From: Richard Henderson <rhenderson@davidsonsgroup.co.uk>
Sent: 25 June 2025 17:16
To: Alex Jelley; Planning Folder New
Cc: Matthew Sanders; Aimee Cocking; Bailey Taberham
Subject: 24/00709/REM Desford - Response to LLFA
Attachments: Technical Note - Response to LLFA.pdf; 1089-ENG-0600 Surface Water Drainage Area Plan.pdf; 1089-ENG-1050 Contour Layout.pdf; Davidsons Desford Drainage Calculations.pdf; 1089-ENG-0950 Pond and Swale General Arrangement.pdf; E1089-ENG-0005A - Viability Levels and Drainage Strategy.pdf

Drainage Technical Note-Response to LLFA

DESFORD
1089-TN-0001

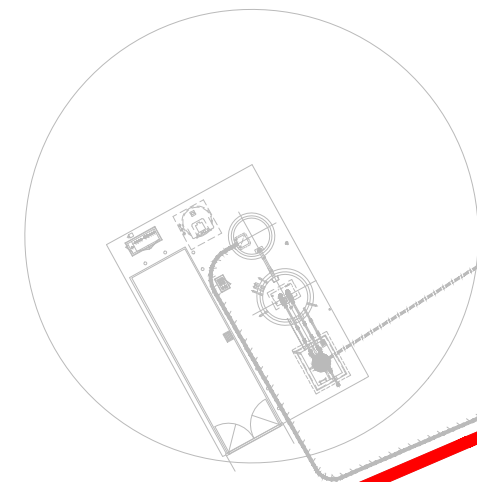
"Once the above strategic level drainage concern has been addressed, the following supporting information should be provided:

A catchment area plan to support a revised set of hydraulic calculations

Flood flow routing plan

Please see attached catchment plan, flood flow routing plan demonstrating overland flows and cross sections of the proposed attenuation basin. The flow control chamber will be offered for adoption as part of a separate S104 process as is standard practice and we do not consider the detailing of this to be within the planning process. Private drainage is to be produced and installed in accordance with the relevant Building Regulations and is also considered to be outside of the scope of planning.

Drainage Strategy

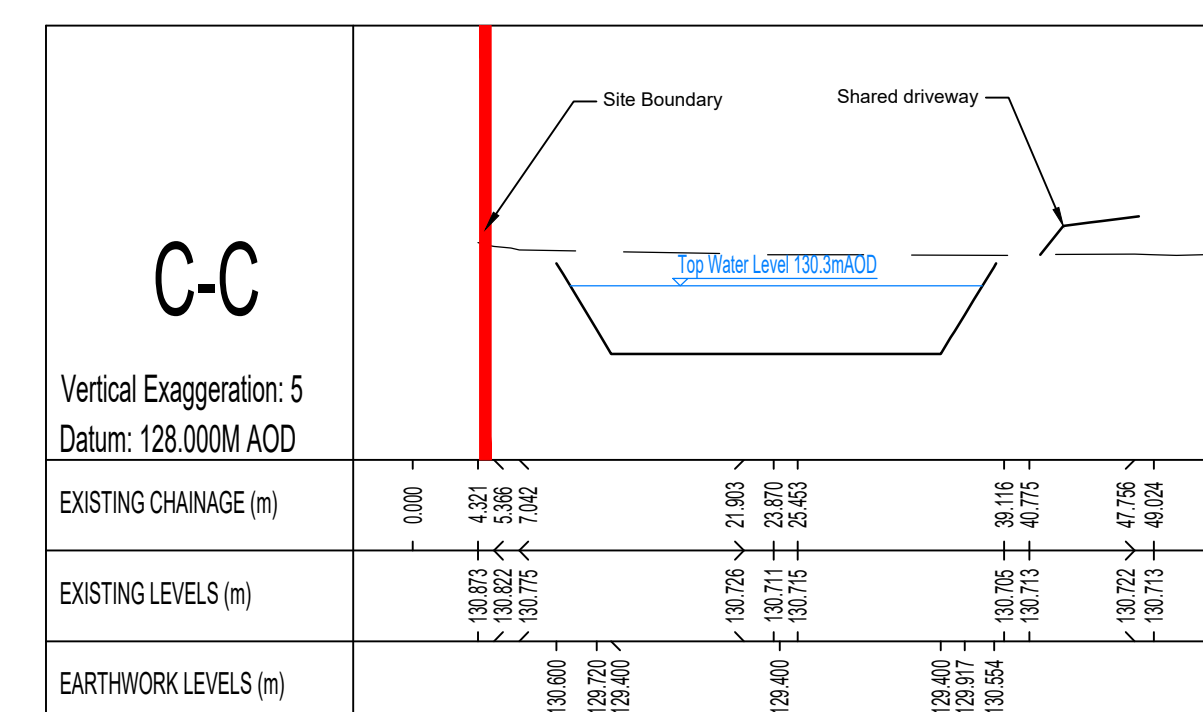
“The proposed site layout has altered slightly from the previous consultation, and from the layout that was approved in 22/01227/OUT. The latest changes show a reduction in the capacity of the attenuation basin from 1413m³ to 1355m³. This change is mostly due to a reduction in the freeboard of the pond from 595mm to 300mm, which is still compliant with freeboard requirements.”

To compound the LLFA’s concerns, it is stated on the drainage strategy drawing that the total contributing area to the attenuation volume is 2.491ha, with the hydraulic calculations only accounting for an impermeable area of 1.572ha. The LLFA is concerned that the methodology used to derive the greenfield runoff rate has not been reviewed as part of the detailed design process and as submitted the proposals will result in an increase in flood risk elsewhere, particularly to the immediate downstream community of Desford.

As noted, this is compliant with requirements.

The site is proposed to discharge at 23.5l/s. This is the rate stipulated within the Flood Risk Assessment and below the rate stipulated as a maximum flow rate by STW as part of the original outline application (5l/s/ha).

The proposed discharge rate is consistent with the rate shown within the drainage strategy that was included within the flood risk assessment and the layout, whilst updated as part of this reserved matters application to reflect the detailed design, retains the principles of the undeveloped perimeter and development extents. As the proposed scheme does not vary in these principles from that within the Flood Risk Assessment it is considered that the proposed discharge rate remains unchanged from that approved.
